Providence City Plan Commission

AGENDA ITEM 5 - 47 MATILDA STREET

20-022MI-47 Matilda Street

Minor Land Development

Proposed site plan

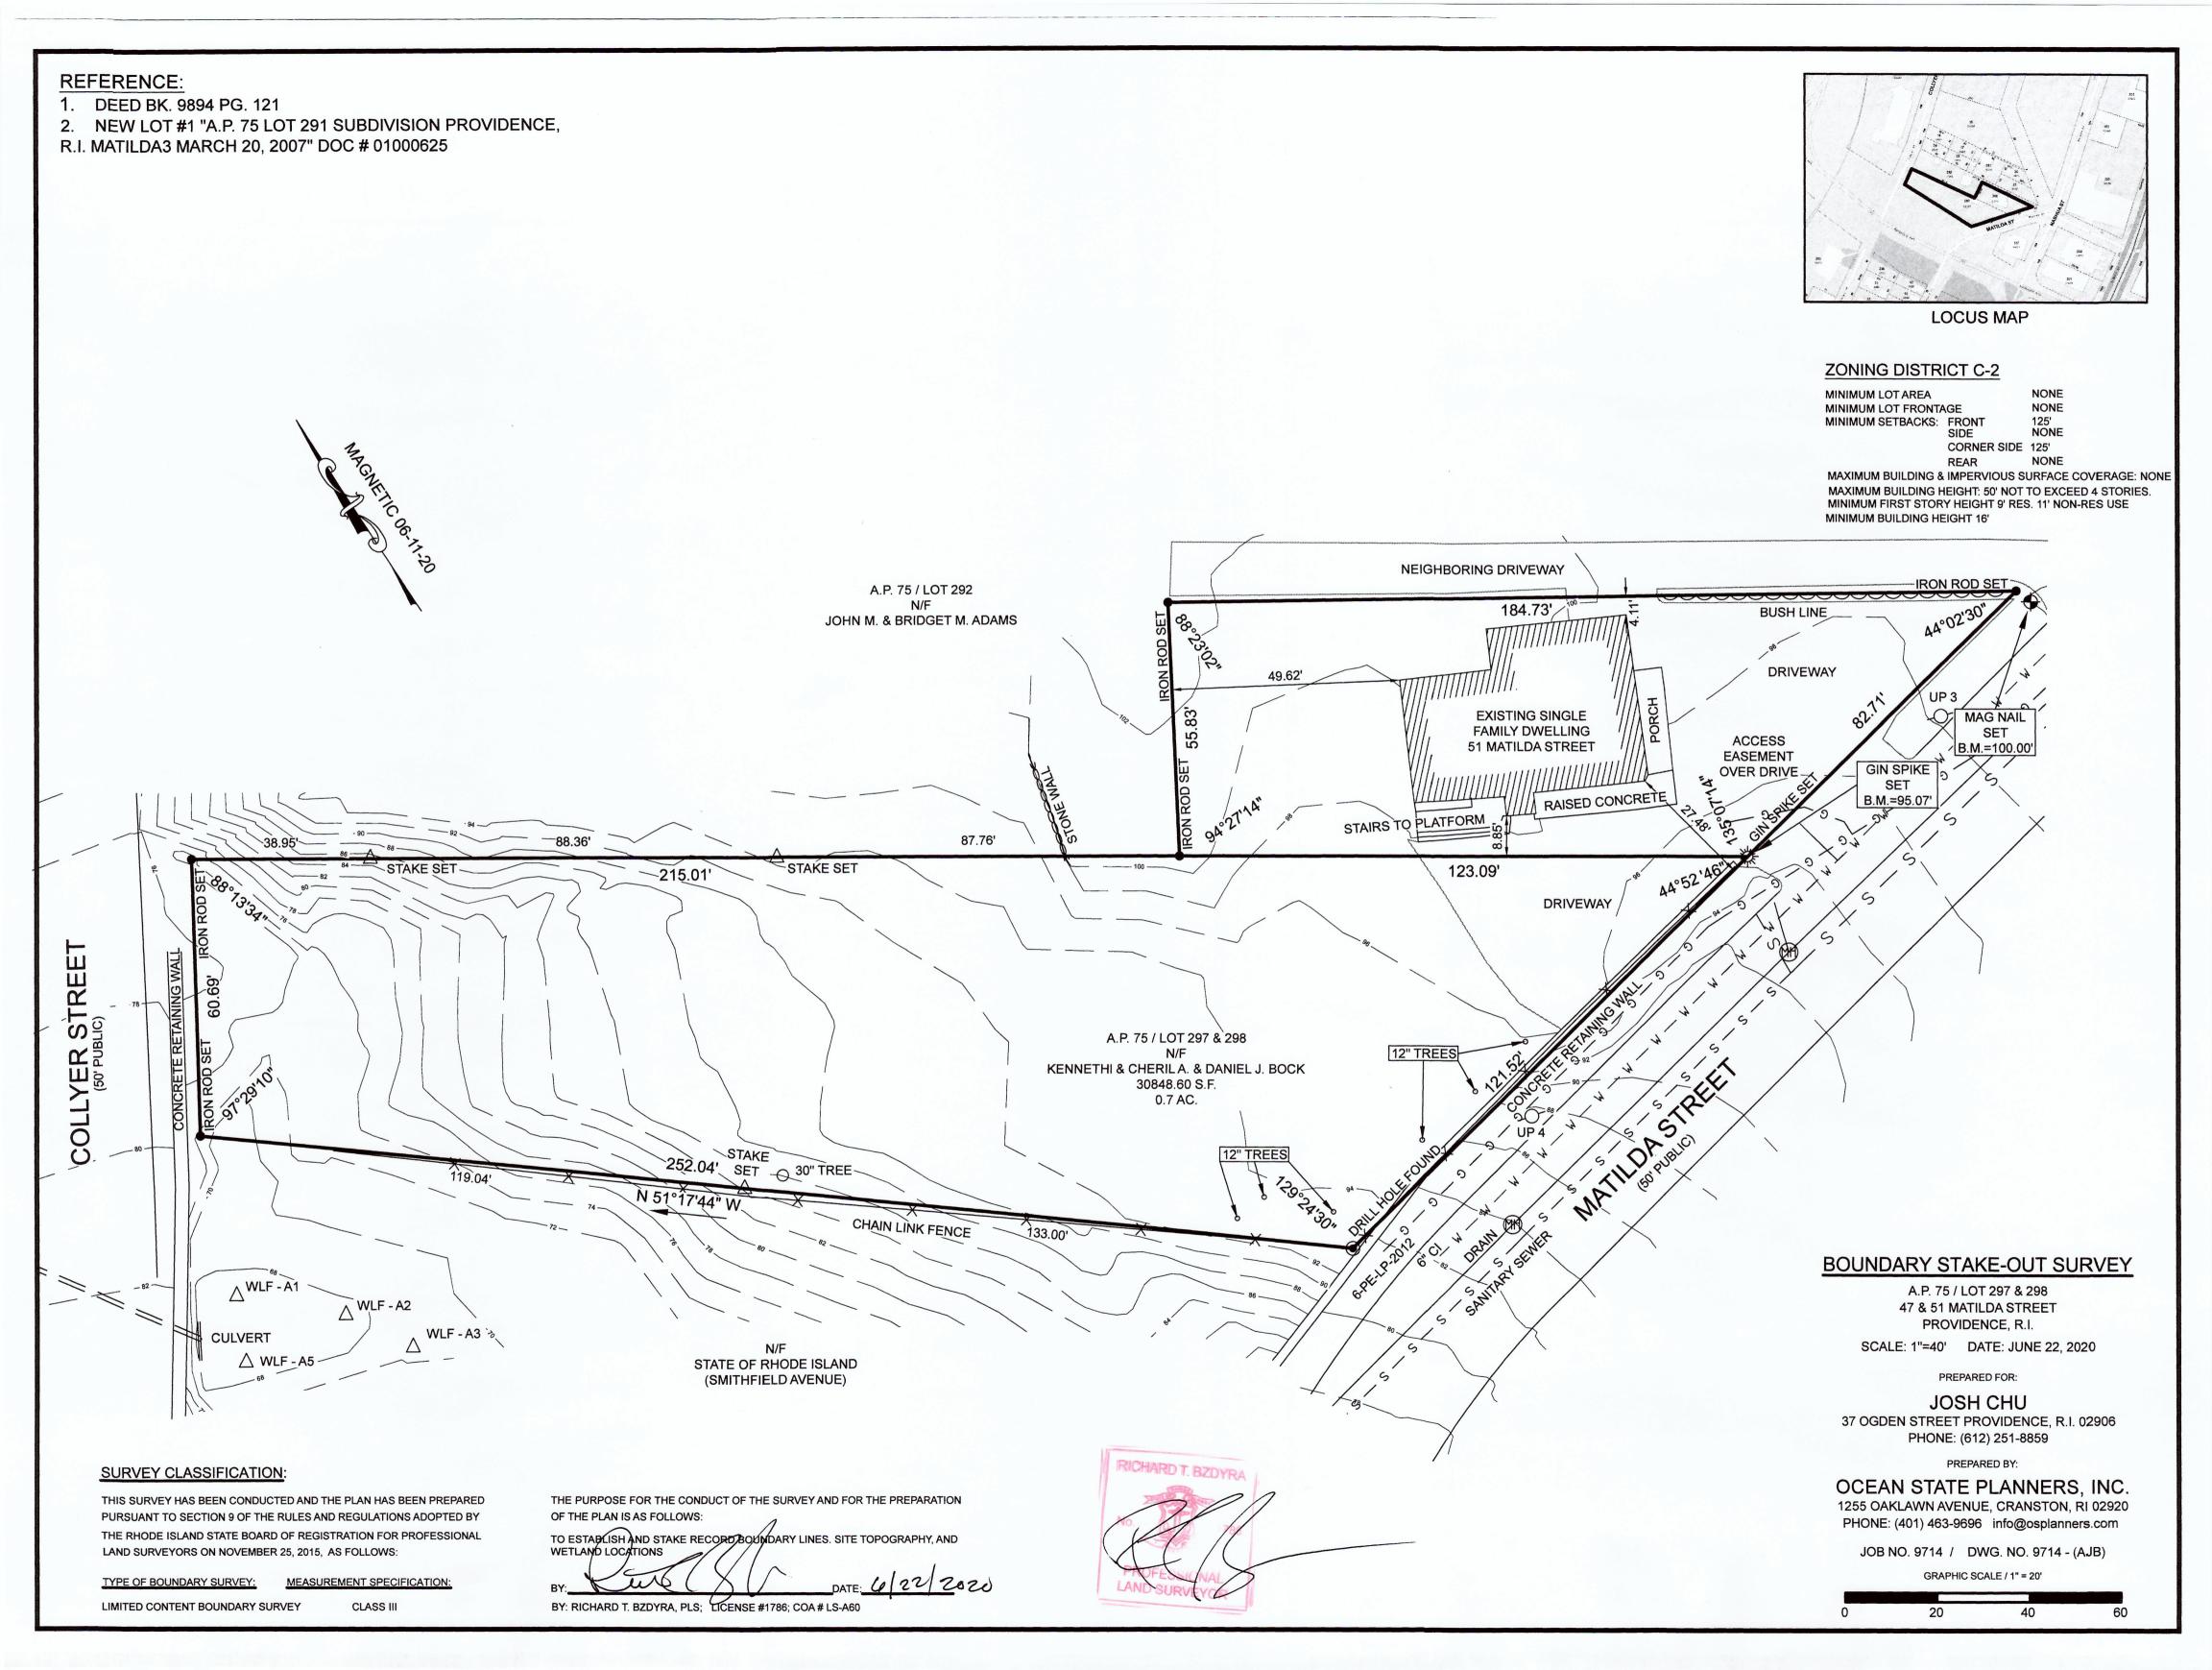
Multifamily building: The 11 unit multifamily building is proposed at the eastern portion of the lot adjacent to Matilda Street, which is designated as the front yard. Design waivers to situate the building outside the build-to zone, and for the front yard setback have been requested. Per the site plan, the building will be located off a driveway originating on Matilda Street. The four story building, which is approximately 40' tall from average grade, will have a footprint of 2,180 SF and provide a mix of one and two family units. The height is within the TODs' height limit of 70'. The building's design will incorporate a unifying architectural theme with a recessed entrance and balconies on the upper stories. A cornice will break up the roofline.

Per the applicant, design waivers from the build-to percentage requirement, and for situating the multifamily building outside the build-to zone on Matilda Street are being requested due to the unique characteristics of the lot which make it difficult to meet the requirement. The entrance to the lot is located at an elevation above Matilda Street. In order to have the building front on the street, the applicant would be required to break a retaining wall, which could affect the integrity of the landscape and incur significant cost. As proposed, the site will be accessed from a driveway off the street and lead toward the building, which is at a lower grade from the entrance and set back from the front lot line. Given the irregular topography, the applicant will be unable to meet the design guidelines for the zone. The DPD recommends that the CPC grant the waiver as it is required due to the unique configuration of the site.

The CPC should grant the requested design waivers from the build-to percentage and build-to zone requirements, finding that they are required due to the site's configuration.

Upon approving the waivers, the CPC should approve the preliminary plan subject to the following conditions:

- 1. The validity of the preliminary plan should be extended to one year from the date of recording of the approval letter.
- 2. The final landscaping plan shall be subject to the City Forester's approval.
- 3. The drainage plan shall be subject to the City Engineer's approval.
- 4. Final plan approval should be delegated to DPD staff.
